Informal document No. 23
*(85th GRSG, 21-24 October 2003
agenda item 3)*

OICA PROPOSAL FOR DRAFT AMENDMENTS TO DOCUMENT
TRANS/WP.29/GRSG/2003/20
UN/ECE R107.01 (DUBBLE DECK BUSES)

**"Figure 13b
Space for seated passengers behind a seat
and or/ a seat facing the gangway
(see paragraph 7.7.8.5.2) "**

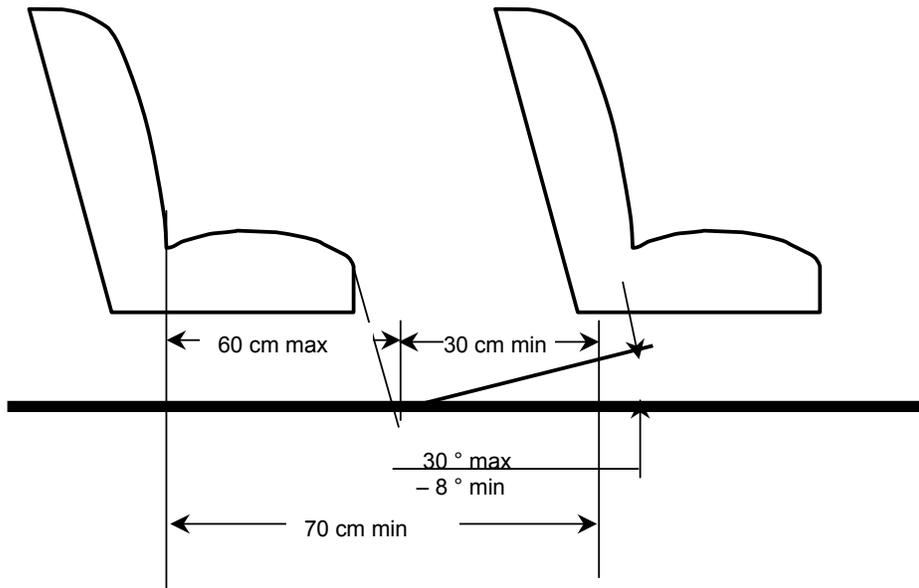
"7.7.8.5.2. For a seat behind a seat and/or a seat facing the gangway, a minimum clear foot space of at least 300 mm depth and a width **equal to that specified for a seat cushion in paragraph 7.7.8.1.1., reduced where appropriate by paragraph 7.7.8.6,** shall be provided **as shown in Annex 3, figure 13b.** The local presence in this space of seat legs shall be permitted provided that adequate space remains for the passengers' feet. This foot space may partly be situated in and/or above the gangway but shall not create any obstruction when measuring the gangway-width in accordance with paragraph 7.7.5. **In the case of seats alongside the driver's seat in vehicles with up to 22 passengers, intrusion of the seat belts and seat belt anchorages shall be allowed. "**

Insert a new drawing:

1. to clarify the interpretation of paragraph 7.7.8.5.1. and Annex 4 figure 13, which was intended not to impose any additional requirements on seat spacing but instead to determine the clear space between a passenger seat and a partition or other rigid structure other than a seat, and
2. to clarify that the foot space in front of each passenger seat may be so located such that parts of the foot space "intrude" into the gangway, either on the floor or above it. In any case, while measuring the gangway width with the respective testing gauge, the foot space shall not obstruct movement of the gauge.
